**BEFORE THE HEARINGS PANEL
FOR THE PROPOSED QUEENSTOWN LAKES DISTRICT PLAN**

IN THE MATTER of Hearing Stream 14:
Wakatipu Basin hearing
and transferred Stage 1
submissions related to
Arrowtown and Lake
Hayes

**SECOND SUPPLEMENTARY STATEMENT OF EVIDENCE OF BRIDGET MARY
GILBERT ON BEHALF OF QUEENSTOWN LAKES DISTRICT COUNCIL**

Primary submitter:
Trojan Helmet (2387)

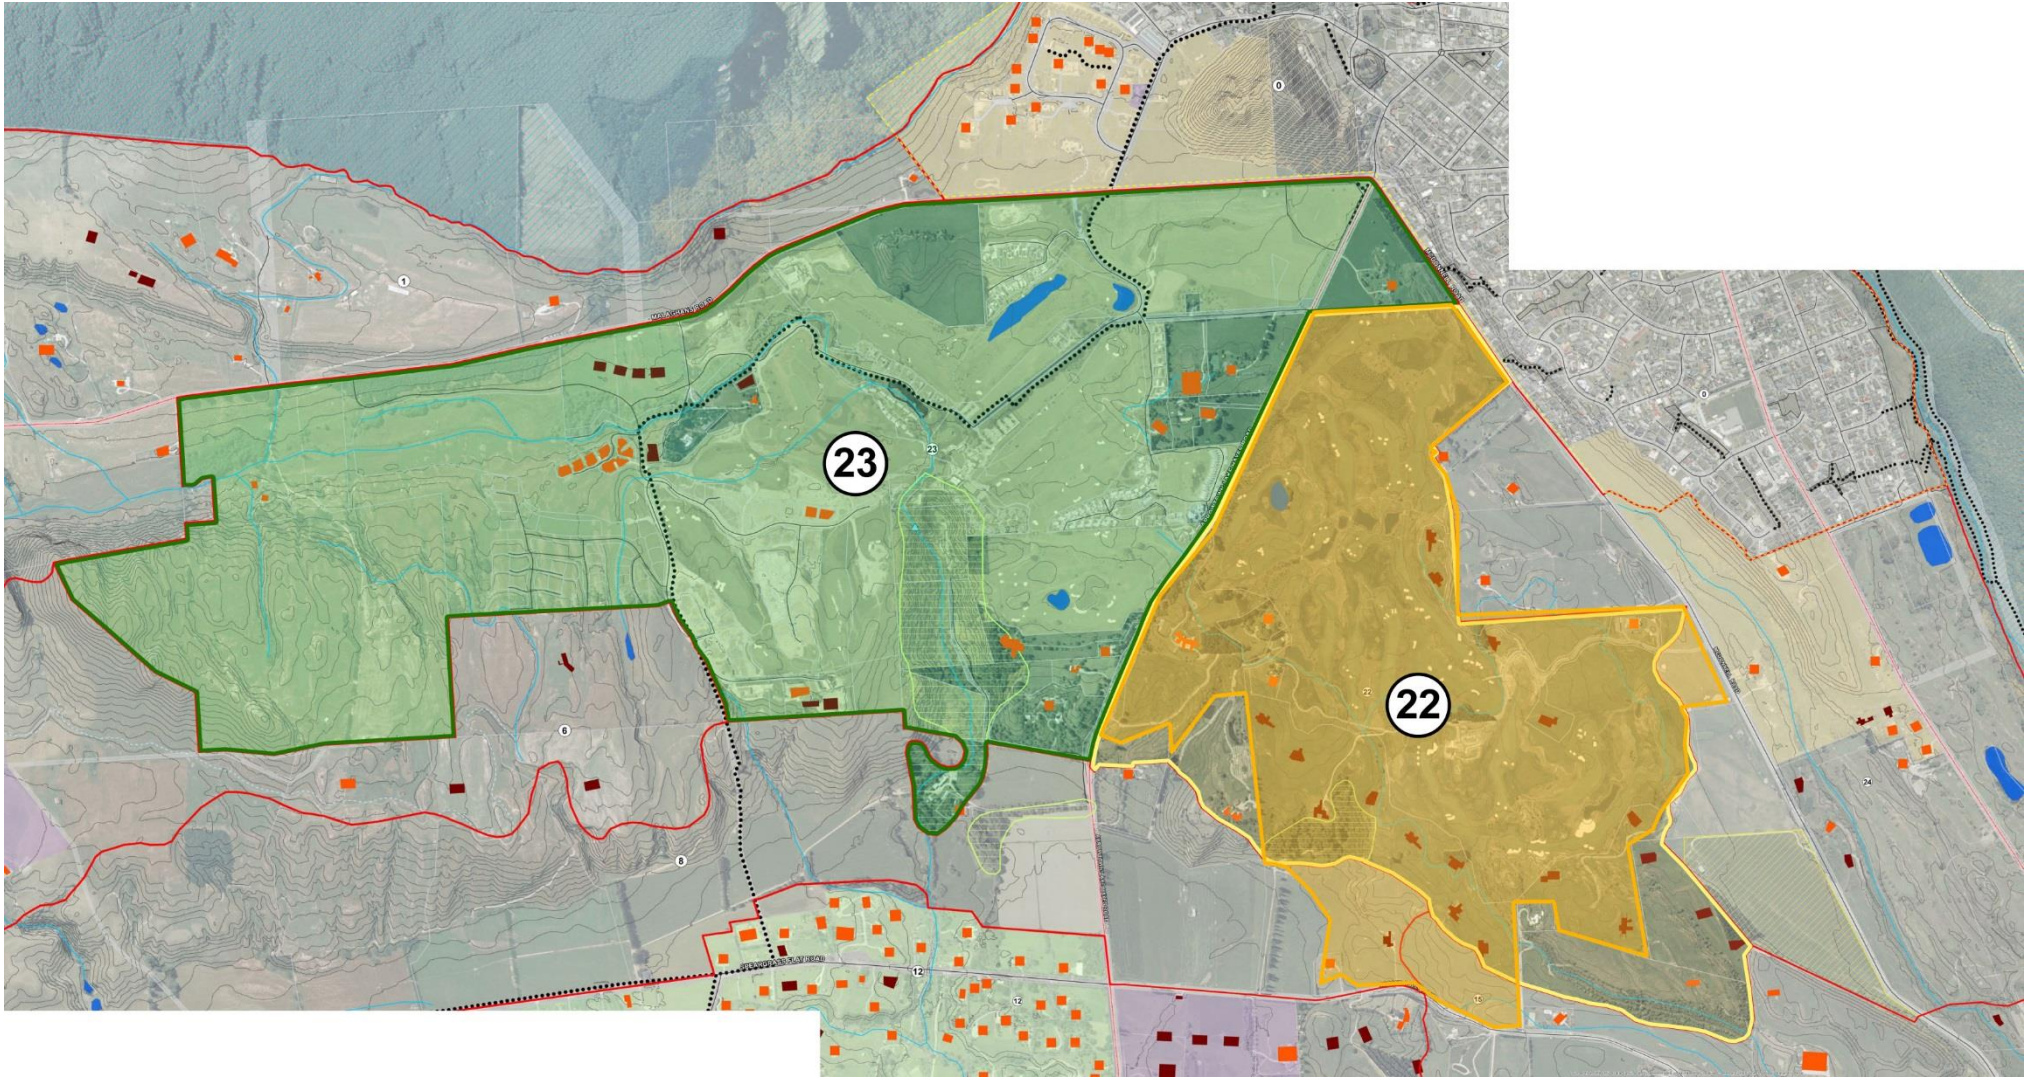
- 2.8** I note that the PDP Millbrook Resort Zone covers some 384ha and that the submitter's proposed Hills Resort Zone is effectively contiguous with Millbrook (albeit separated by Arrowtown Lake Hayes Road) - refer **Figure 1** below.

- 2.9** In my opinion the BML Report fails to meaningfully evaluate how an approximately 162ha extension of resort style development throughout this portion of the Basin (that will result in a total resort area of approximately 546ha), which effectively contains the southwestern sides of Arrowtown, will influence the sense of place or identity of the wider Basin landscape.

- 2.13** Unlike the small-scale 'cut out' areas around the edges of Millbrook where I have expressed support for an extension of the Millbrook Resort Zone, I consider that the submitter's proposed Hills Resort Zone amounts to a large-scale change in the quantum of urban parkland type development throughout the north eastern portion of the Basin.

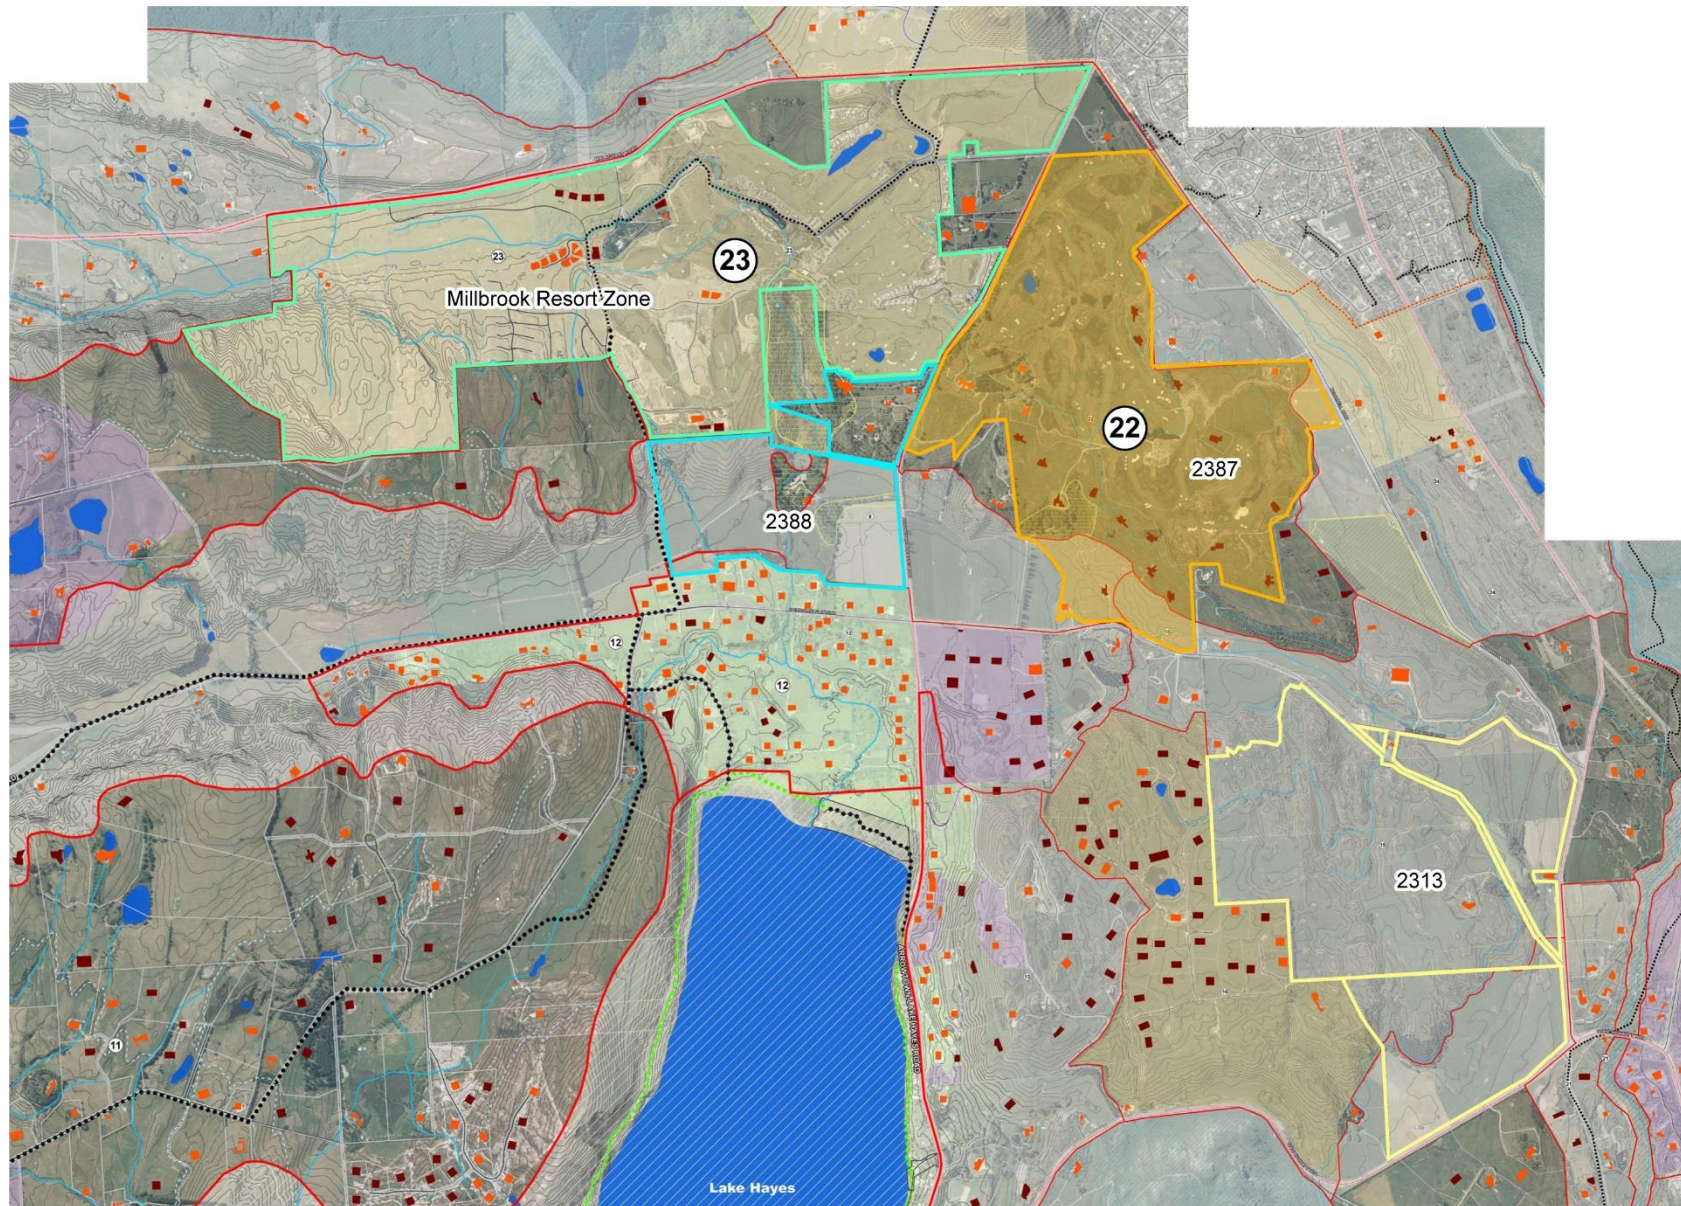
- 2.15** In evaluating this submission, I have also considered the potential cumulative effect of the Hogans Gully Farm Limited submission (2313),¹ which seeks a similar golf resort style zoning on approximately 159ha of land in close proximity to the south east of the Trojan Helmet submission area, and the Waterfall Park Developments Limited submission (2388),² which seeks urban development set within open space on land to the south of PDP Millbrook Resort and PDP Waterfall Park Zone. **Figure 2** below conveys this spatial arrangement.
